Elephant & Castle to Crystal Palace Quietway (QW7)

Wilson Road to Lettsom Street

Main Consultation Issues and Responses

Detailed Consultation Comments and Responses

QW7 – WILSON ROAD TO LETTSOM STREET

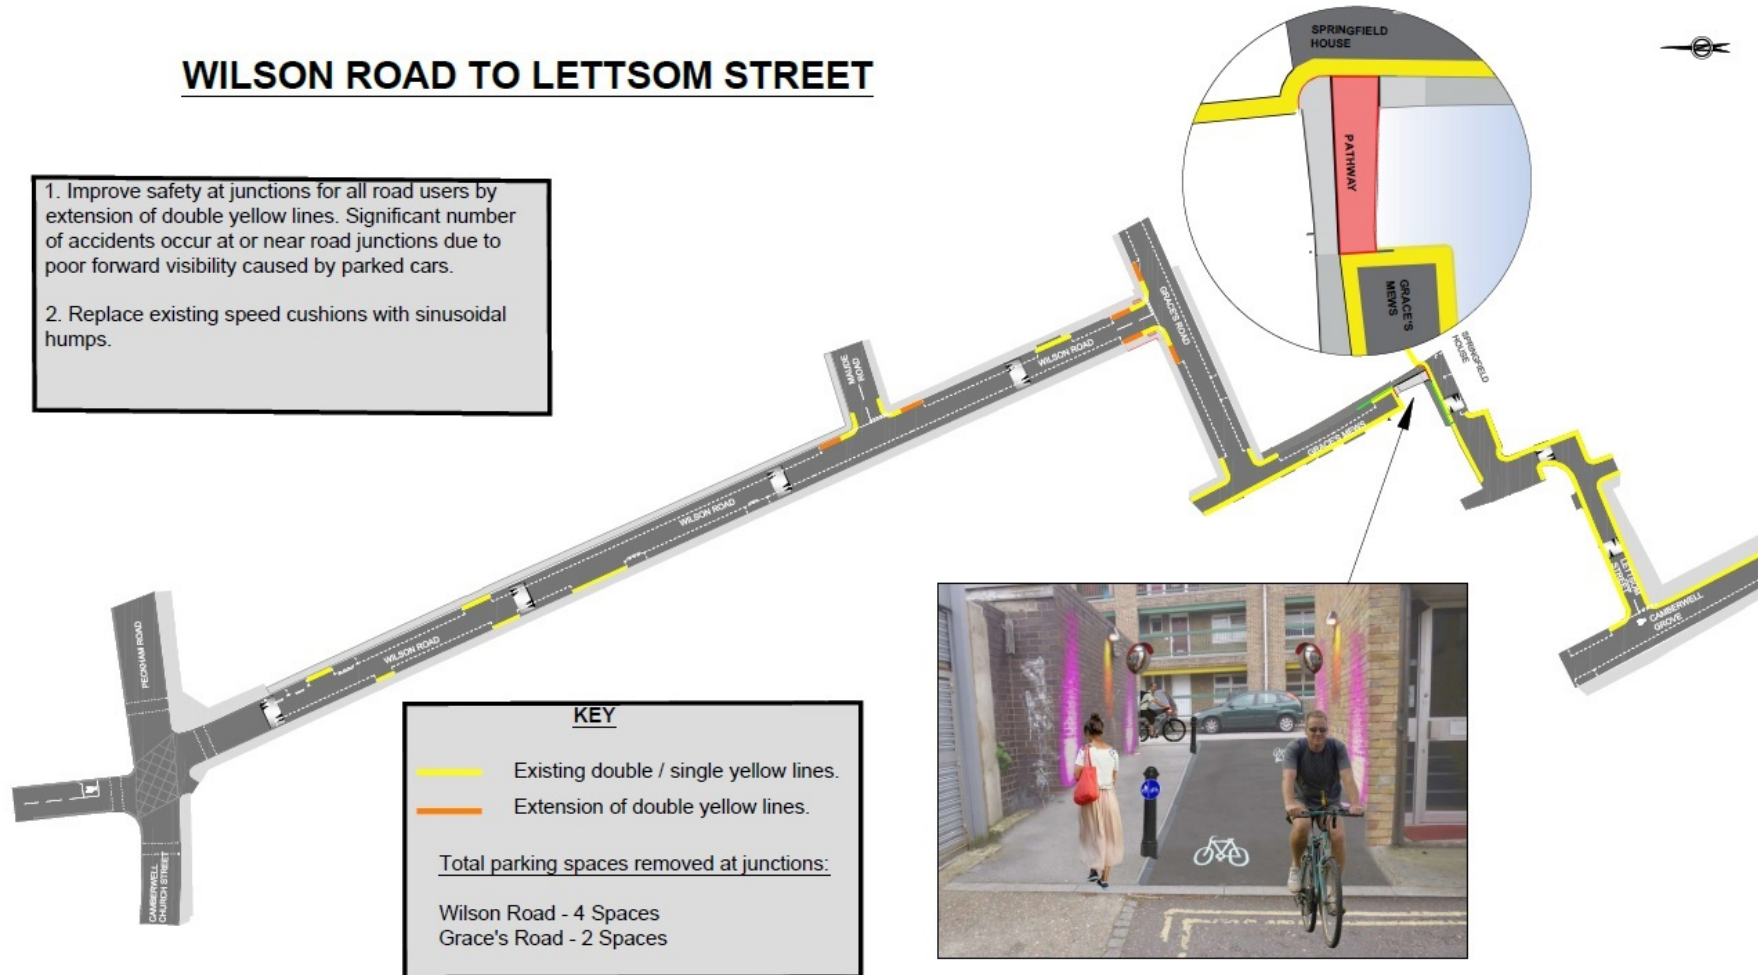
Proposal	Concern/Objection	Response
Overall	Inadequate provision for cyclists at Peckham Road / Wilson Road / Benhill Road junction.	The signal timings on South alignment of Peckham Road/Benhill Road are appropriate to operate safe QW. As this junction is part of the TLRN, any concerns related to cyclist and pedestrian safety will be raised with TfL.
	Lack of proposals on Camberwell Grove	Further traffic re-assignment analysis is currently being carried out to investigate measures to reduce the number of motor vehicles using Camberwell Grove as a through route. Measures for Camberwell Grove are also being considered.
Extension of double yellow lines	Loss of parking.	The extension of double yellow lines aims at improving visibility at or near junctions to reduce the likelihood of accidents occurring. It is part of LBS strategy to increase safety for all road users as it addresses the conflicts between vehicles as well as between vehicles and cyclists.

Conversion of existing stepped access at Grace's Mews to ramp	Conflict between pedestrians and cyclists	Segregation between pedestrians and cyclists will be provided along the ramp. Additional signing will be considered in detailed design.
	Insufficient lighting at this location.	A street lighting assessment will be undertaken along the whole route as part of this scheme. The introduction of the pathway linking Grace's Mews with Lettsom Street will require a lighting upgrade at this location, as already proposed in the consultation material.
